DAM REPORT

I have the honor to make the following report in relation to the structure known as the Indian Lake Stone Dam Dam.

This dam is situated upon the Outlet of Indian Lake
(Give name of stream)
in the Town of Indian Lake, Hamilton County,

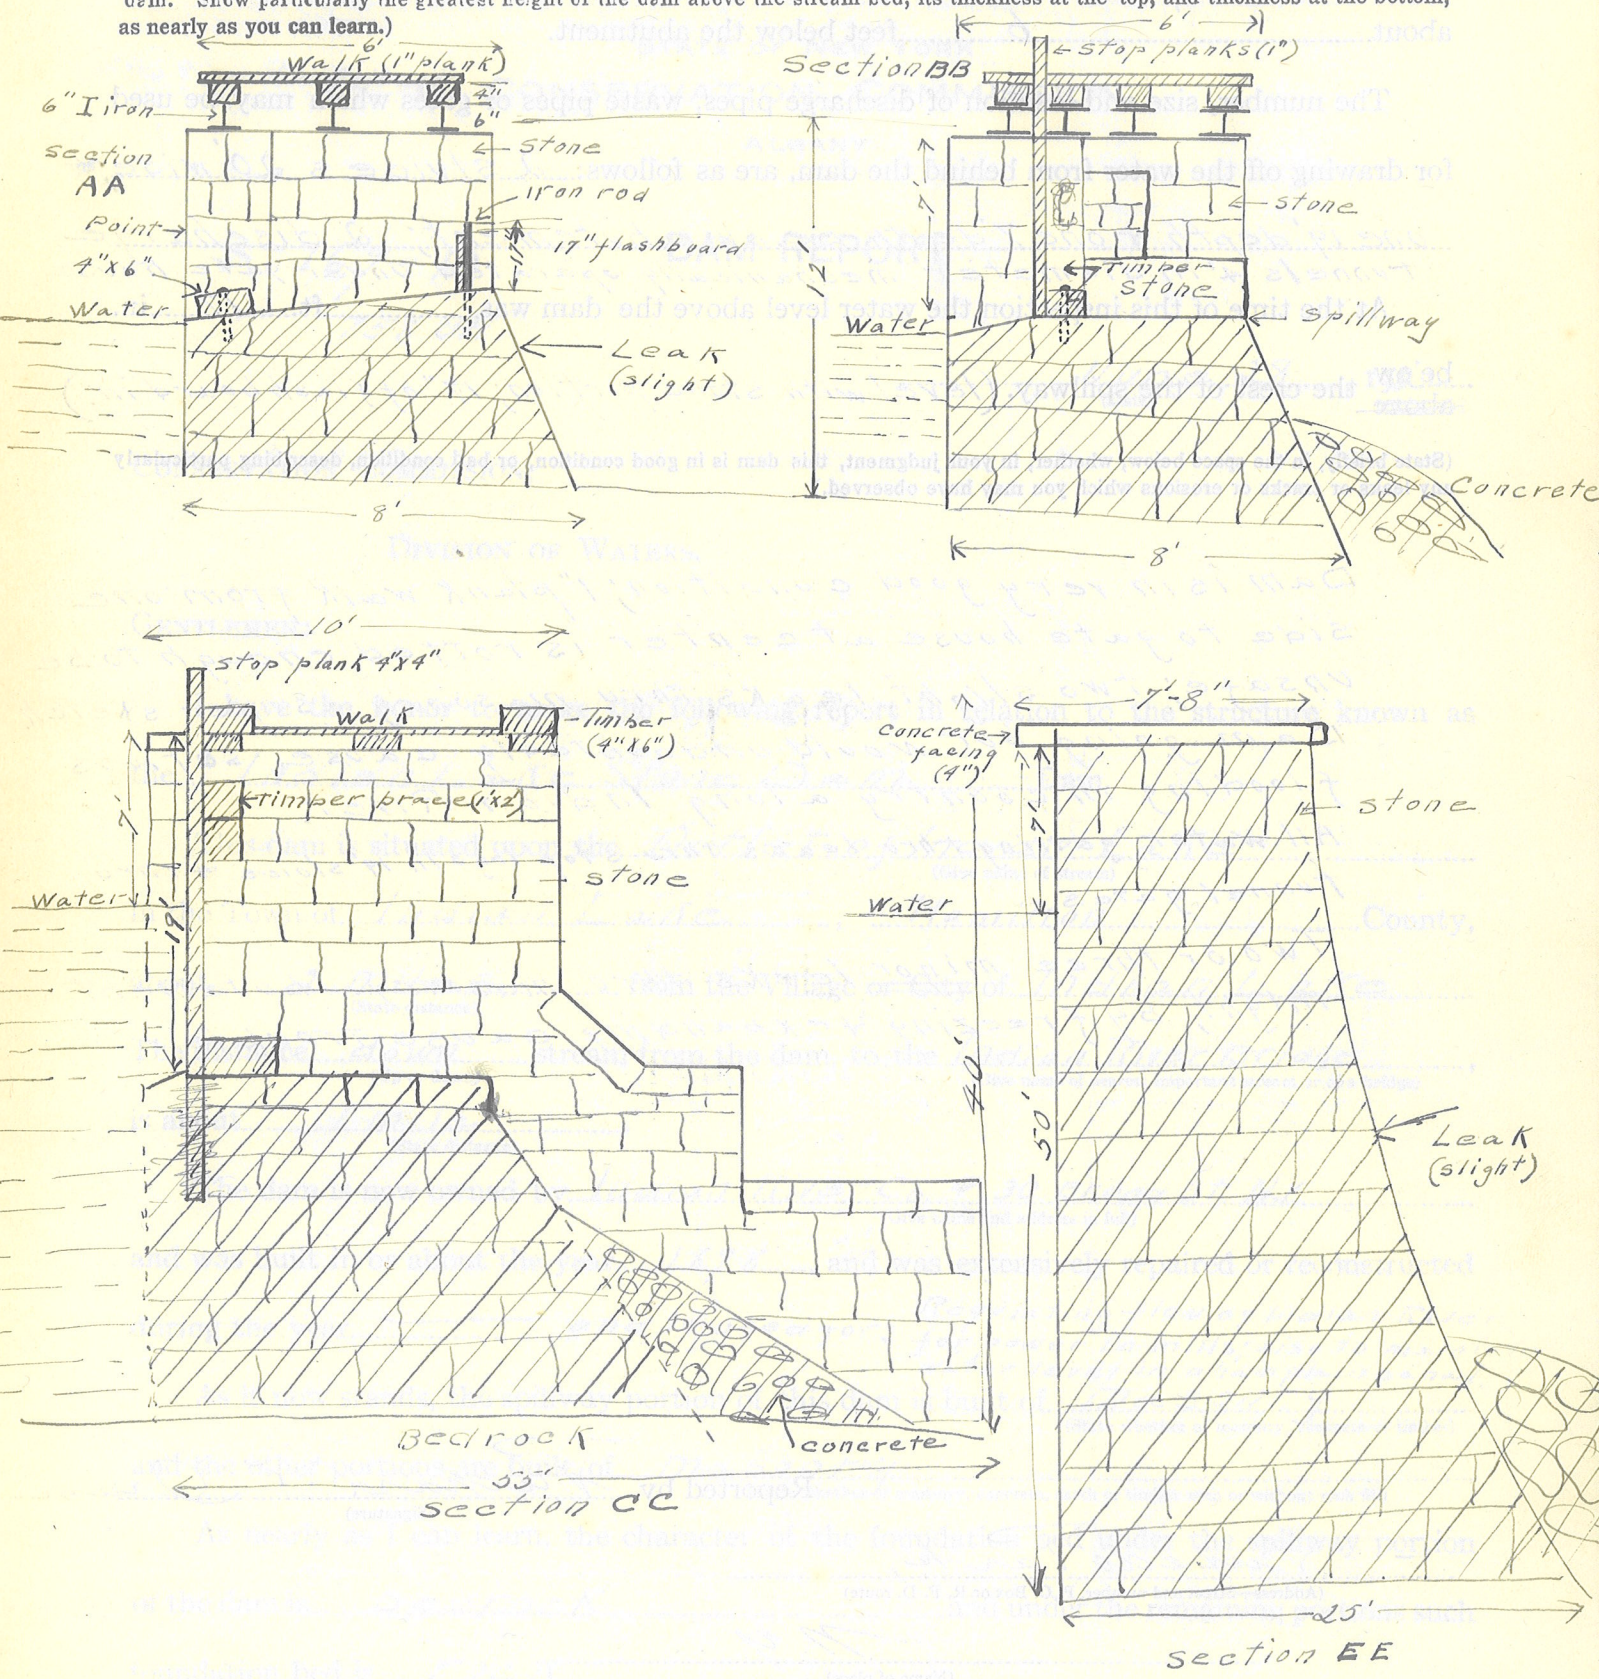
Dam is in very good condition; 1" plank walk from one side to gate house at center is rotted enough to be unsafe; two slight leaks thru masonry as per sketch. Dam going out would undoubtedly cause serious flooding in country along Indian River. All water getting thru leaks thru stop logs in 19' sluice & thru tunnel gates.

Two or three minor leaks thru masonry abutment might, by freezing & expanding cause trouble.
